Three Mile Island Nuclear Station, Unit 1 (TMI-1)
Operating License NO. DPR-50
Docket No. 50-289
Seismic Capability of Backup Thermocouple Reading
And Display System

Response to NRC comments on TMI-1 Seismic capability of backup thermocouple reading and display system.

Figure #1 Response Spectras Used to Qualify Foxboro
NZES Signal Conditioning Rack at TMI-1

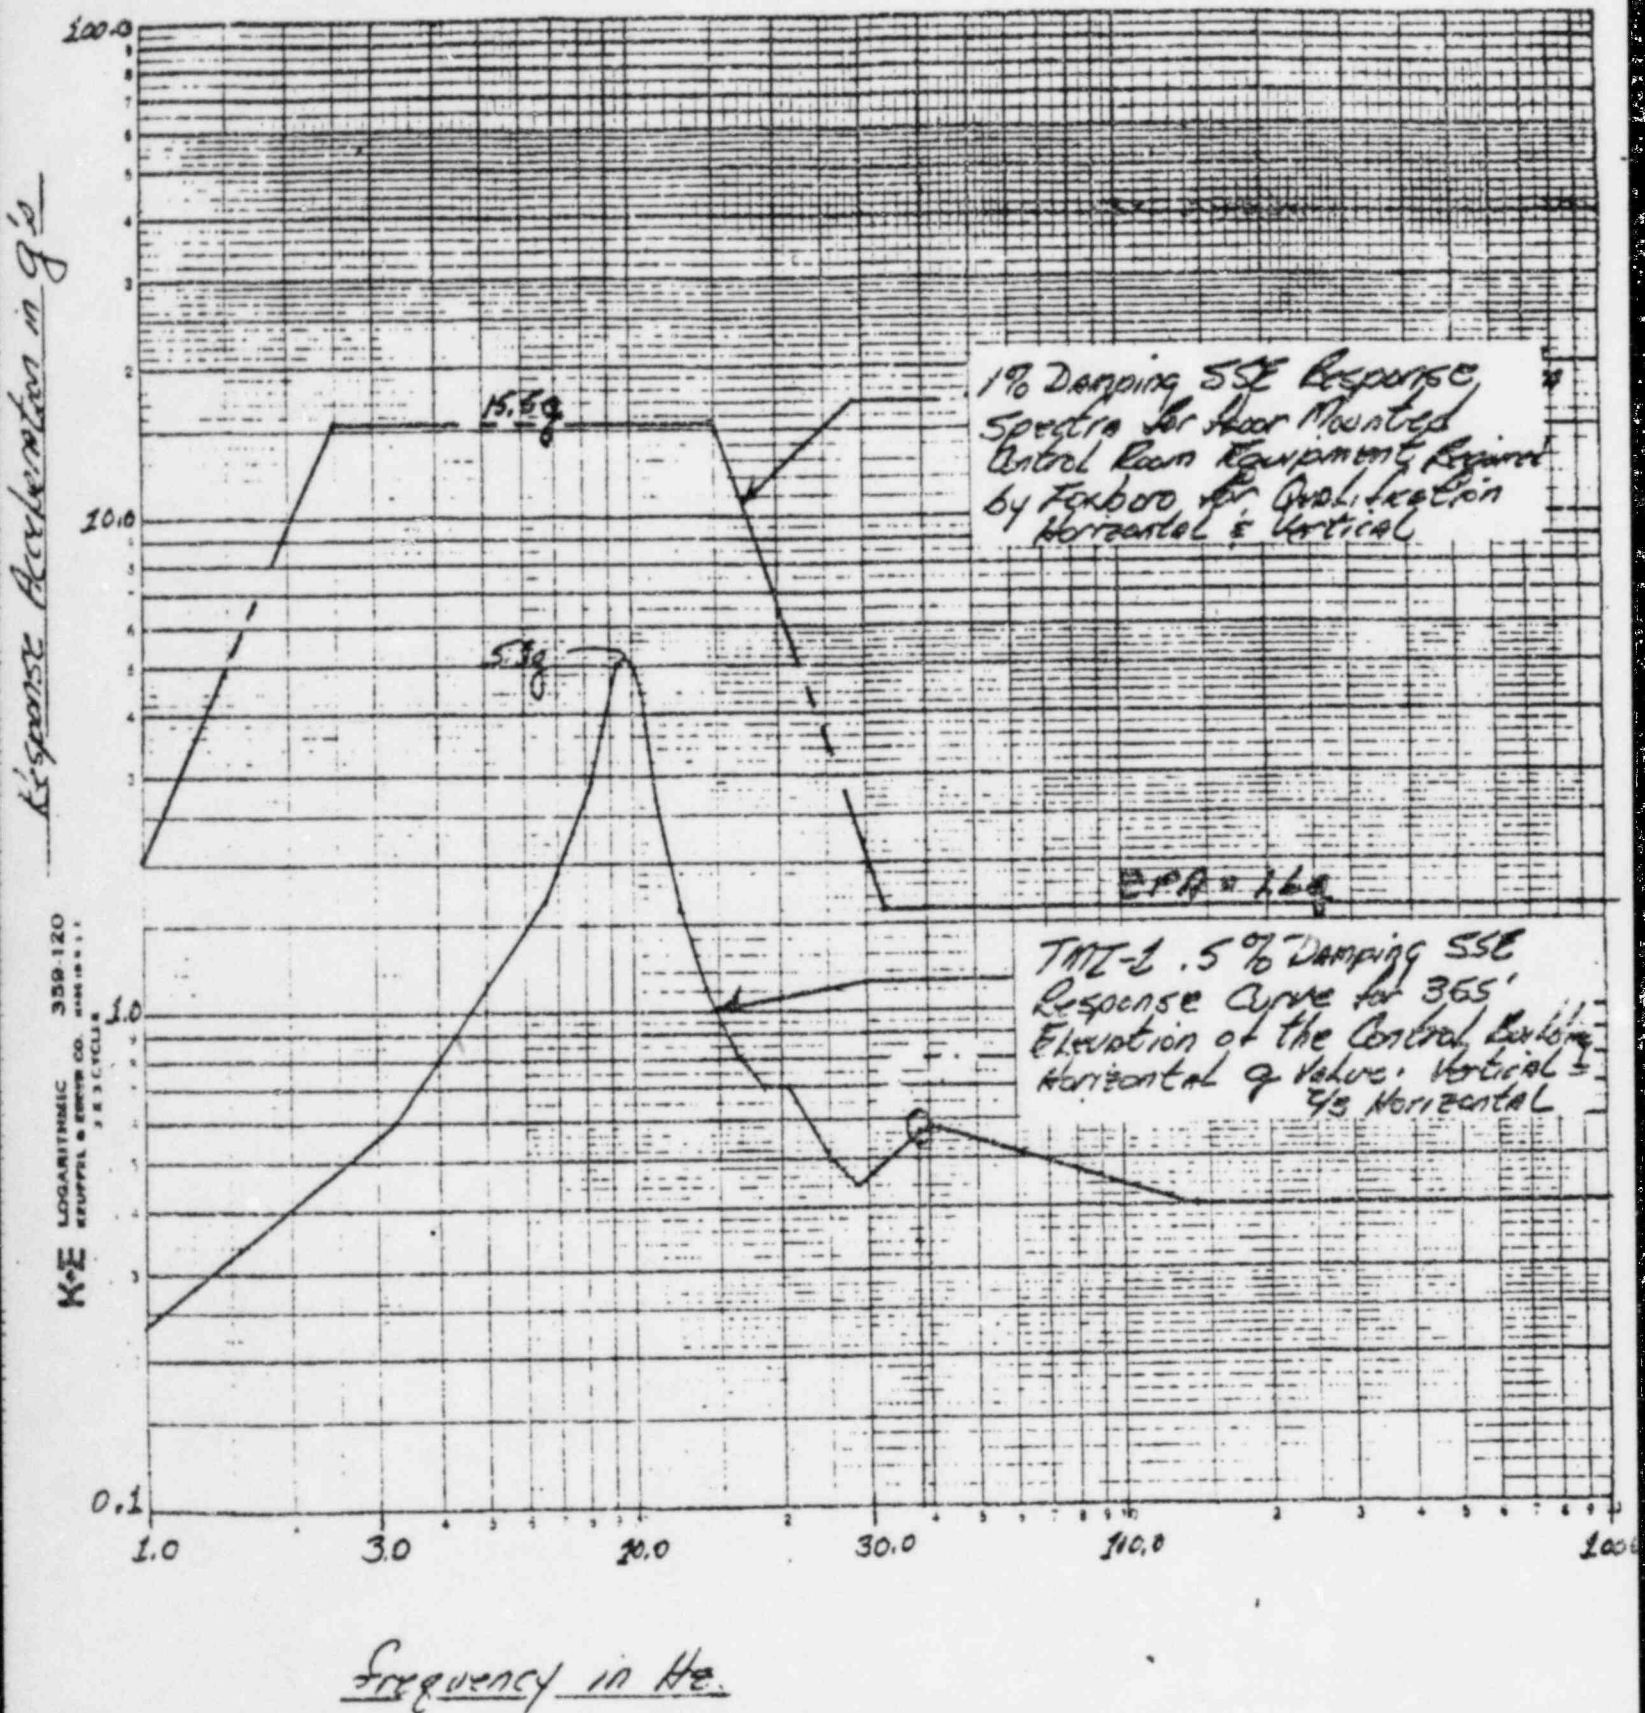
Comment #3: Demonstrate that the signal conditioning unit including its contents has adequate seismic capability.

GPUN has done a Preliminary Evaluation of the as installed N2E5 Foxboro rack, using dynamic test and analytical data supplied by the manufacturer. This data is obtained from a standard dynamic analysis of the subject rack and dynamic test done for Foxboro by Acton Environmental Corporation. The results of the GPUN Evaluation indicated that the first five modal frequencies for the rack are:

The above results indicate that all modal frequencies are above 33Hz. It is well known that components with modal frequencies above 33Hz will respond as rigid bodies during an earthquake, i.e., the dynamic amplification is unity. Consequently, the component can be analyzed in a static manner and transfer functions are such that the response of the component does not show amplification due to the dynamic input.

The qualification response spectrum used by Foxboro for the test of N2E5 racks (installed at TMI) is depicted in the attached figure. The TMI-1 SSE response spectrum for the floor where the rack is installed is also shown in the same figure. It should be noted that the former envelopes the TMI-1 spectrum by at least a factor of 3. Furthermore, during testing, the horizontal and vertical components of the curves were assumed equal and applied simultaneously. In the TMI-1 FSAR, the vertical acceleration is only 2/3 of the horizontal acceleration.

It is GPUN's conclusion that the subject rack (N2E5) is seismically qualified, i.e. it should maintain its structural integrity and remain functional during and after a SSE Event.

SECTION A-A

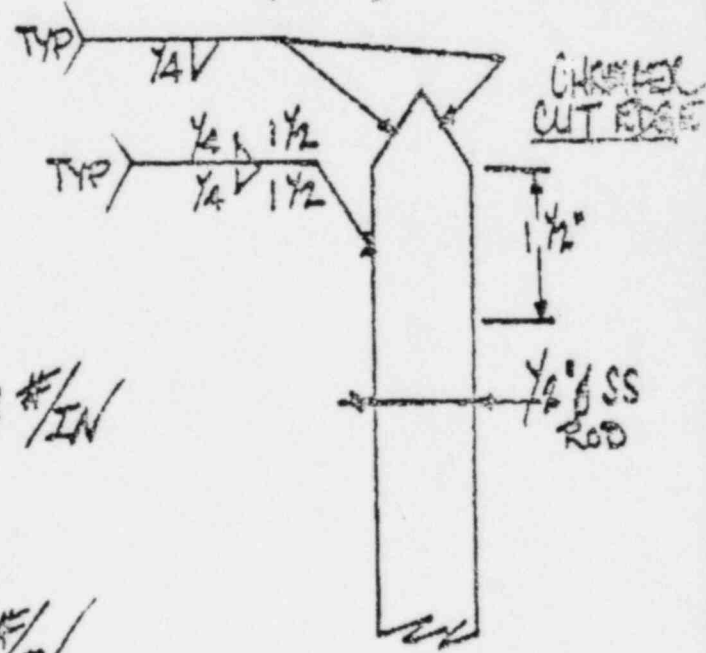
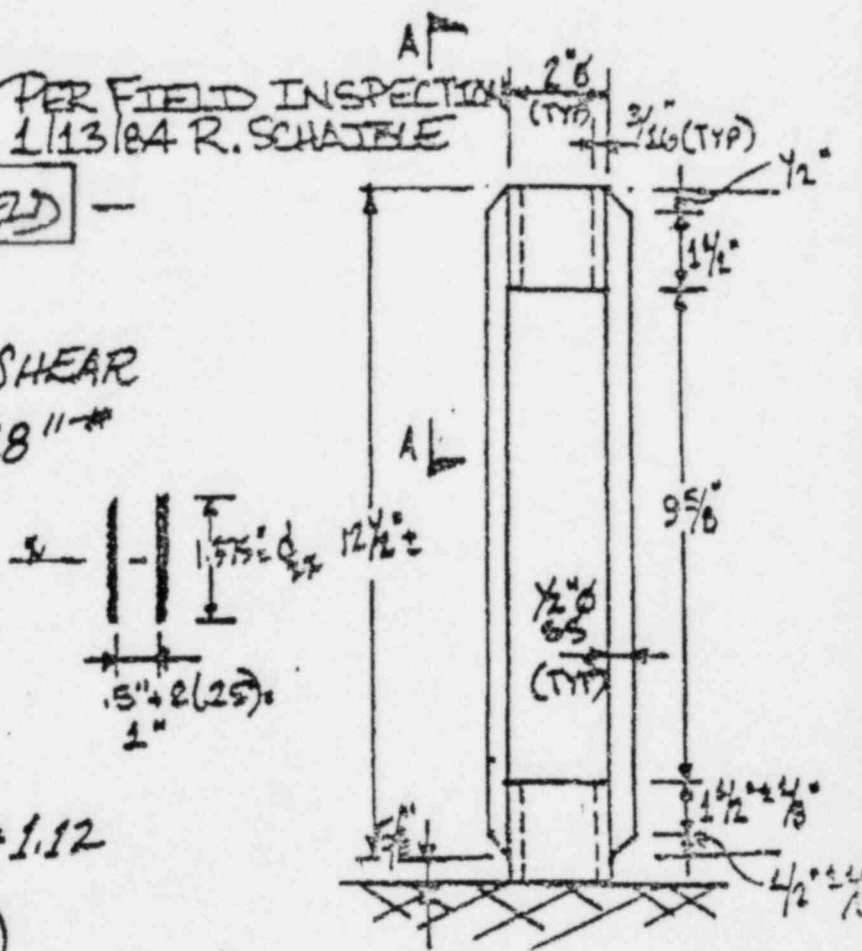
Comment #4: Demonstrate that the welded connections for the thermocouple lead cable sleeves have the required strength.

Response: The cable sleeve to the seal plate welds have been analyzed and added to the subject document (Calc. #C-1101-625-5320-001, rev. 1). This analysis indicates the welds are capable of withstanding the seismic event (SSE), without loss of structural integrity or safety function, and is attached. The two 1/2 in. diameter bars connecting the cable sleeve to the seal plate are detailed in the aforementioned calculations. A copy of the above referenced calculation is included as Attachment 4.

$$\sum f_{\text{WELDS}} = 72.4 + 106 + 3.4 = 262 \#/\text{IN}$$

$$f_{\text{ALLOW}} = .707 \left(\frac{1}{4}''\right) (.3) (62000 \text{ PSI}) = 3288 \#/\text{IN}$$

$\therefore 262 \#/\text{IN} \ll 3288 \#/\text{IN}$ OK
